ADDENDUM NO. 5

DATE: April 21, 2020

FROM: Baxter & Woodman, Inc., Consulting Engineers

VILLAGE OF HOFFMAN ESTATES, ILLINOIS  
GOLF ROAD LIFT STATION REPLACEMENT

**C-1**

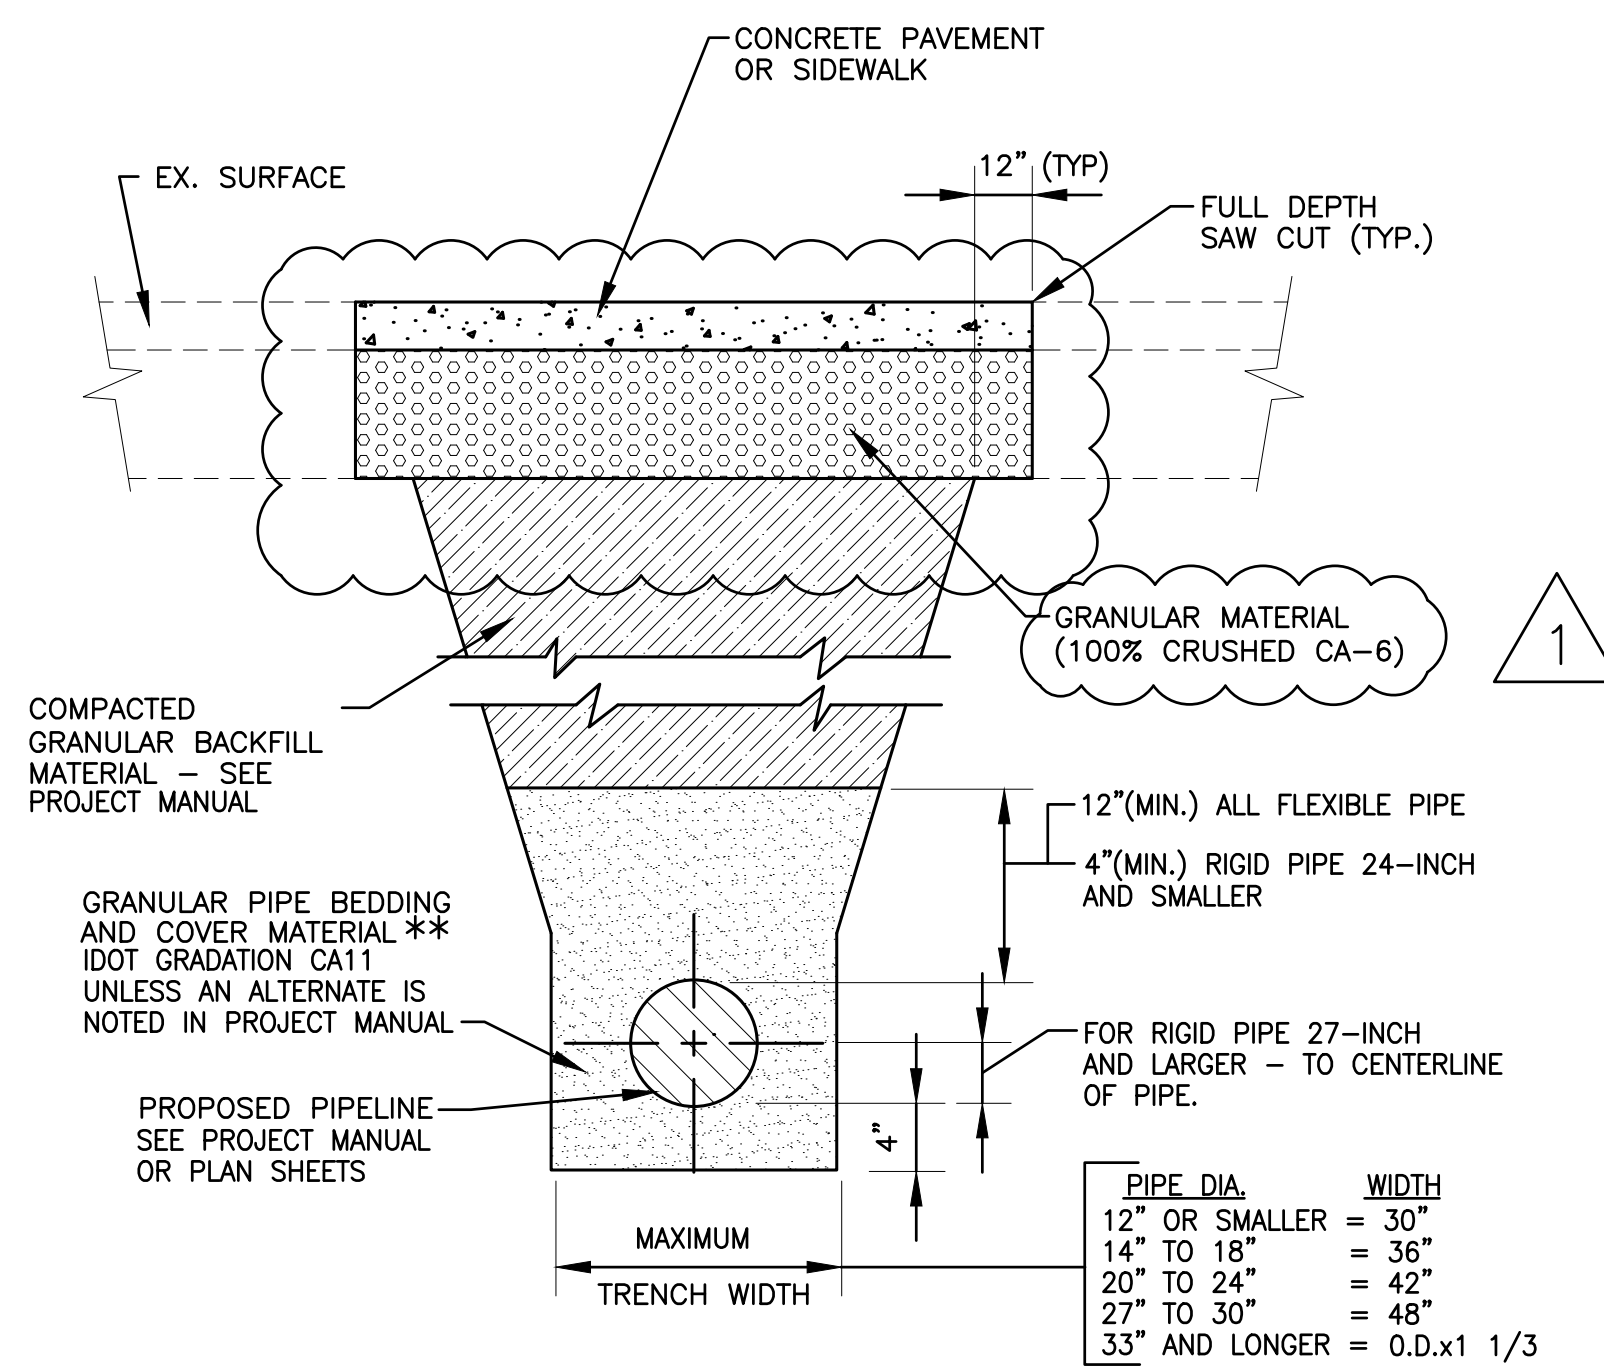
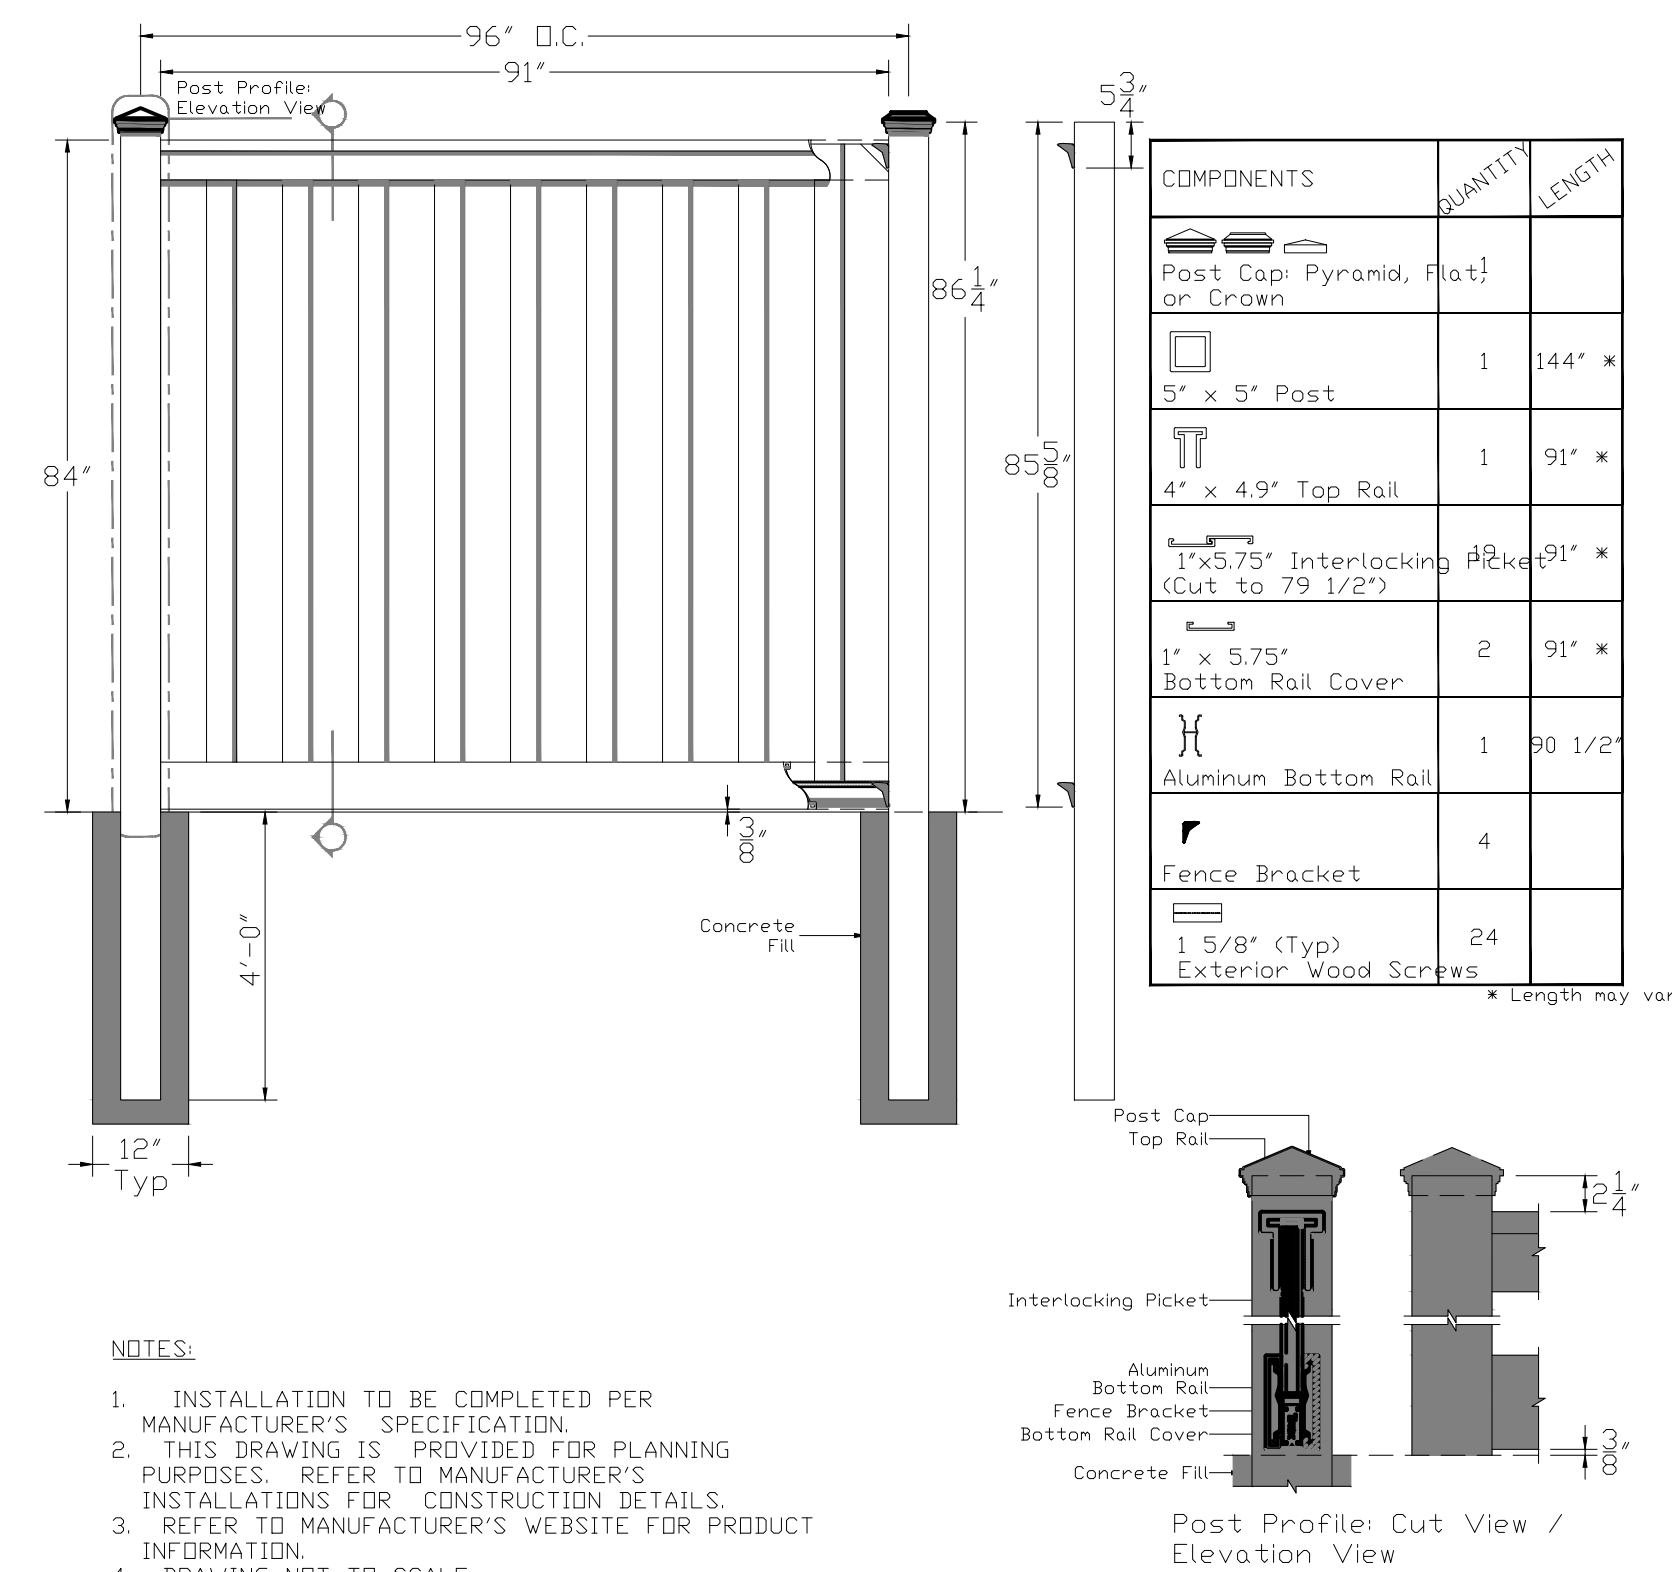
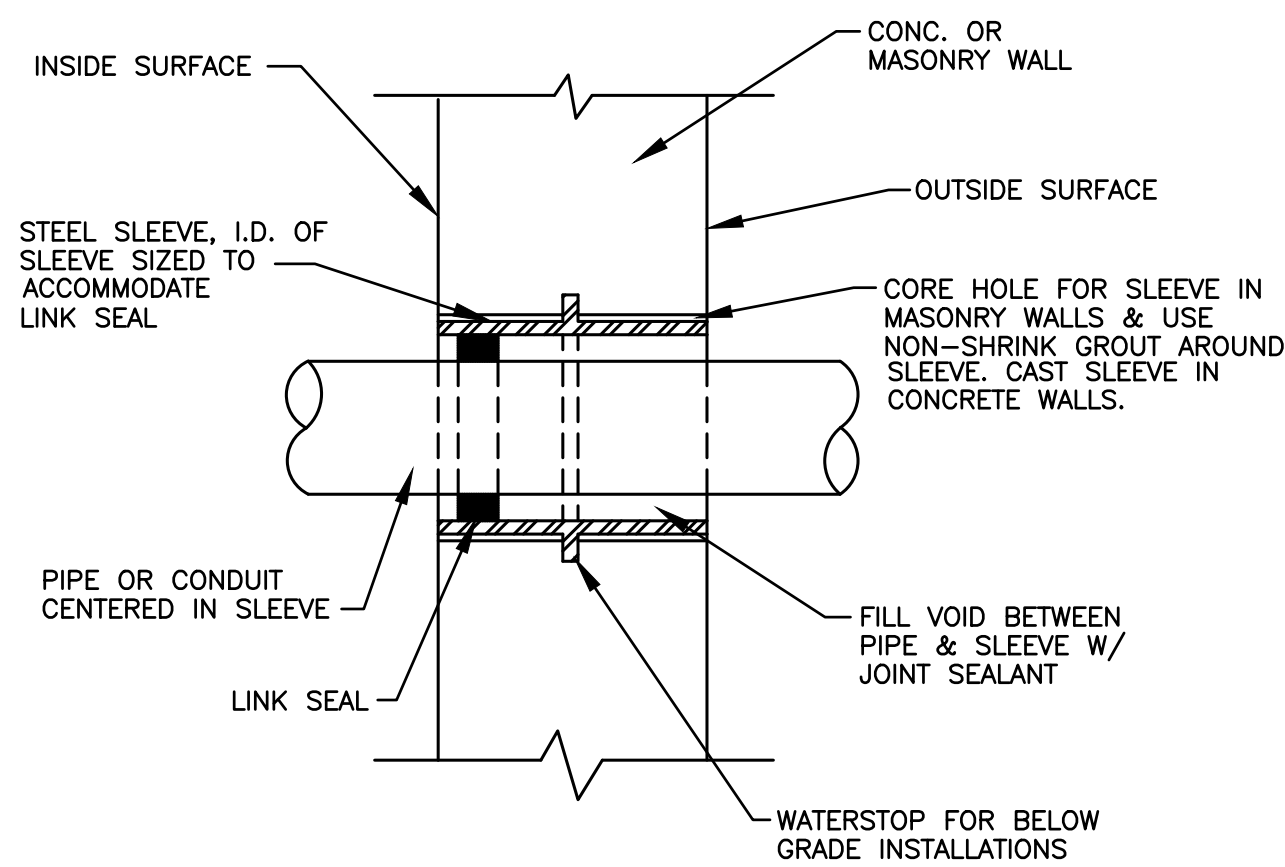
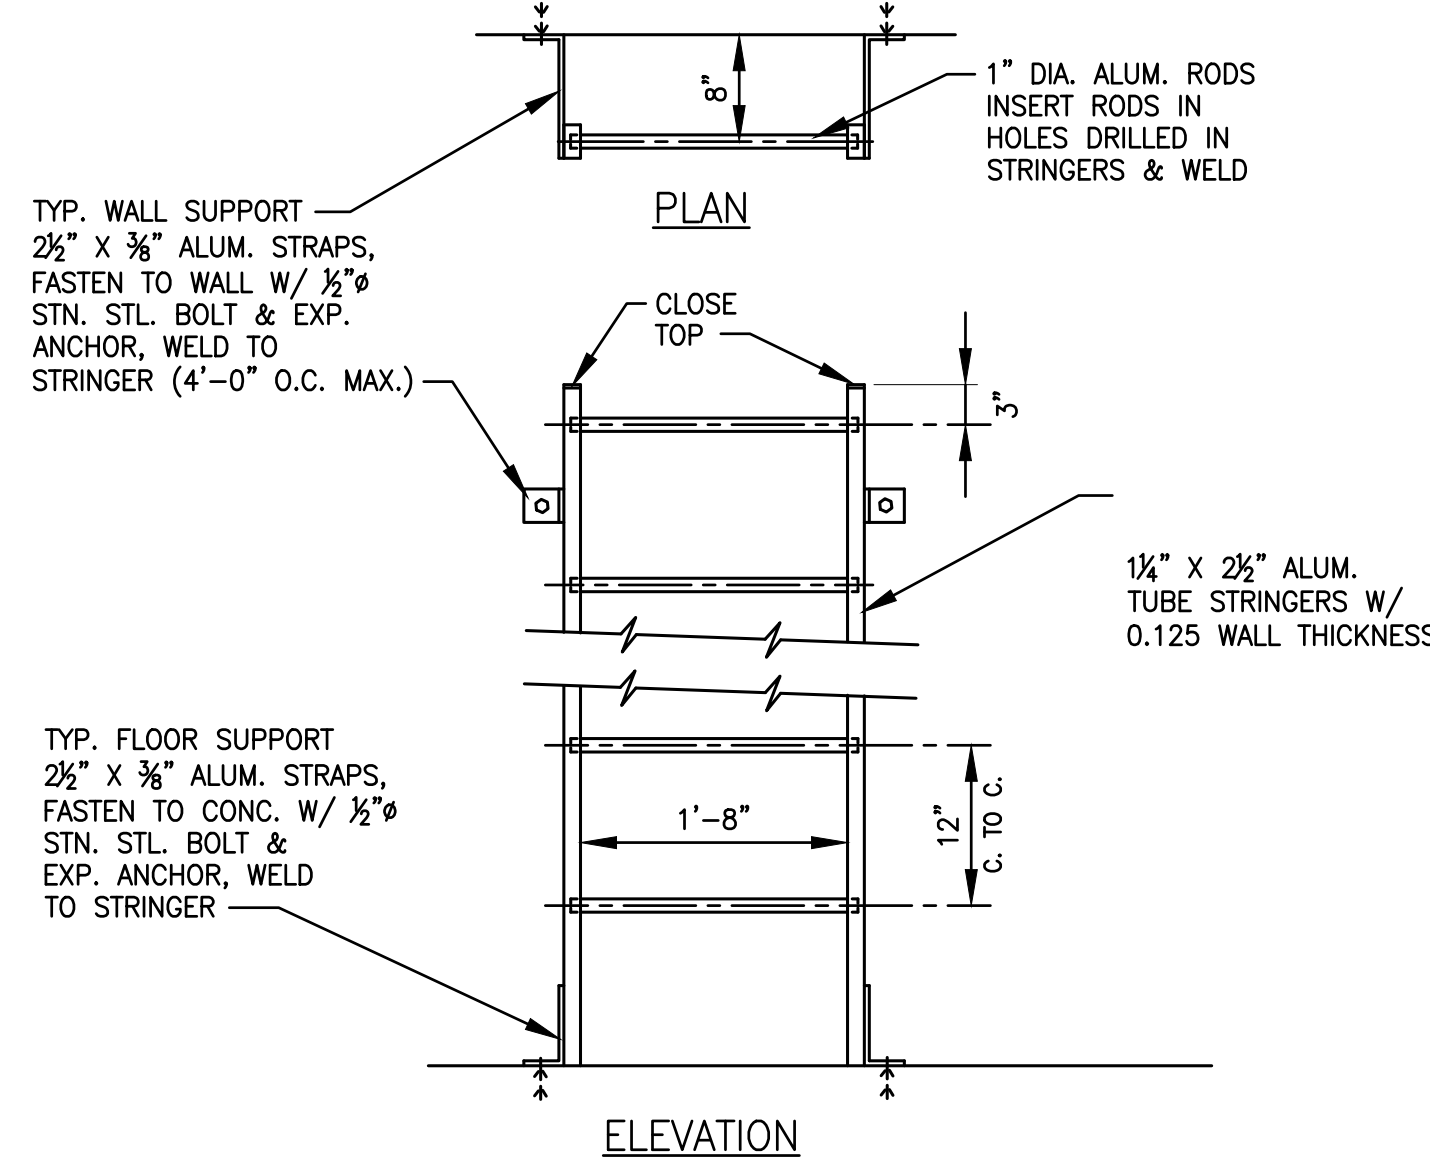
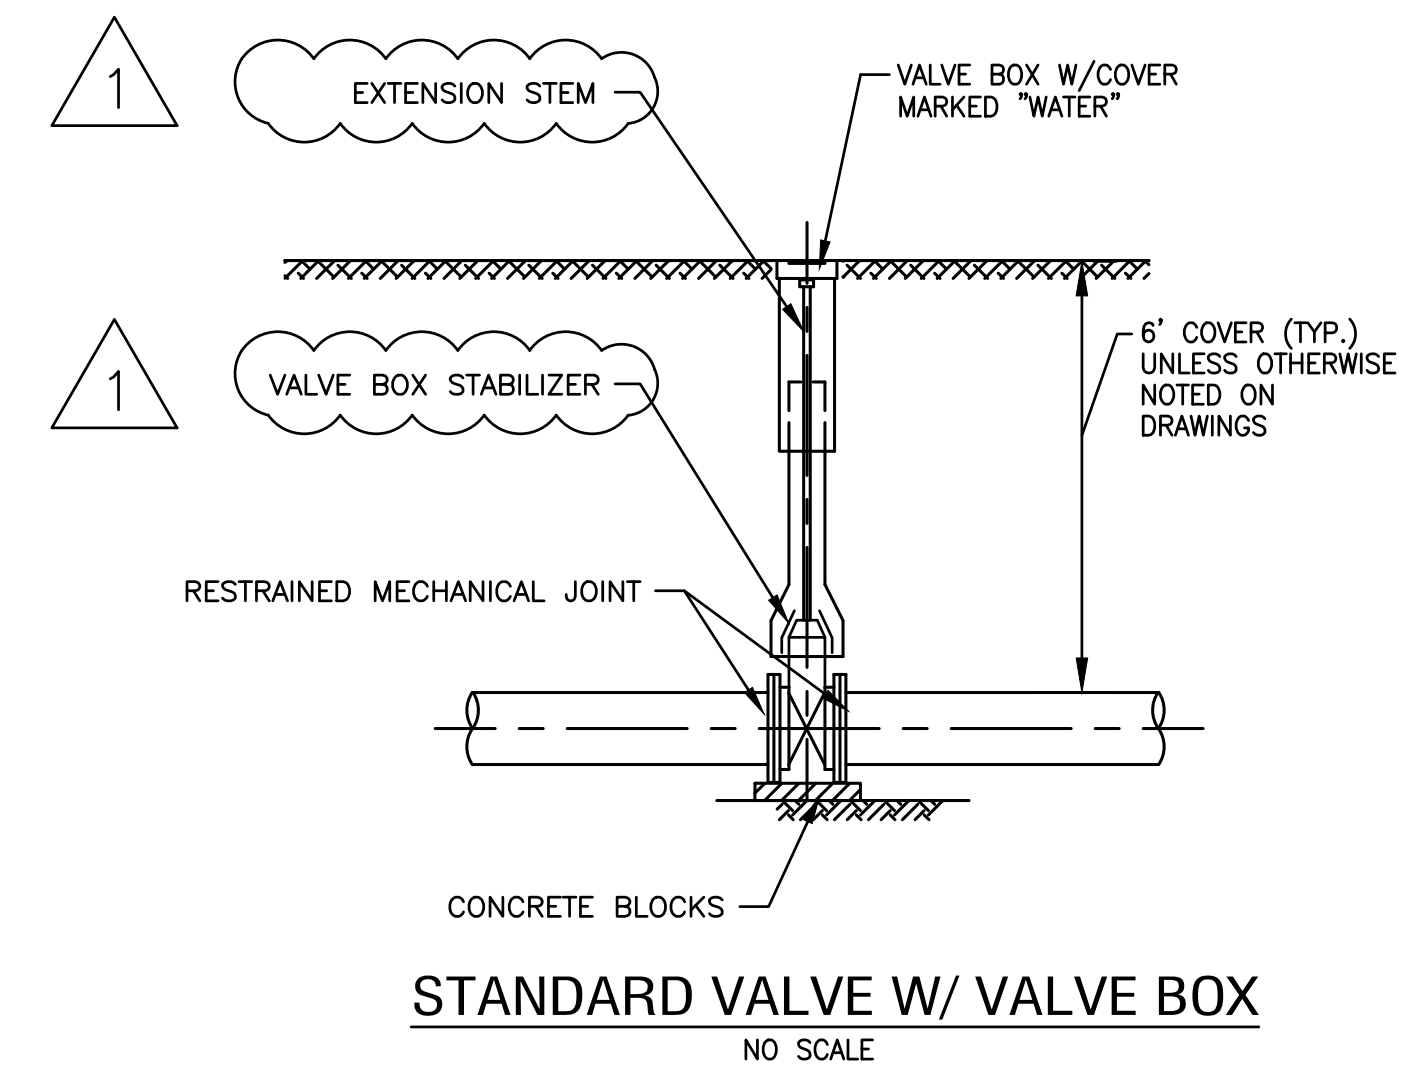
- A. Delete Sheet C-1 in its entirety, and insert attached Sheet M-1, revision dated April 21, 2020 in lieu thereof.
- B. Delete Sheet C-5 in its entirety, and insert attached Sheet M-1, revision dated April 21, 2020 in lieu thereof.
- C. Delete Sheet M-1 in its entirety, and insert attached Sheet M-1, revision dated April 21, 2020 in lieu thereof.
- D. Delete Sheet M-3 in its entirety, and insert attached Sheet M-1, revision dated April 21, 2020 in lieu thereof.
- E. Delete Sheet E-3 in its entirety, and insert attached Sheet M-1, revision dated April 21, 2020 in lieu thereof.
- F. Delete Sheet E-4 in its entirety, and insert attached Sheet M-1, revision dated April 21, 2020 in lieu thereof.
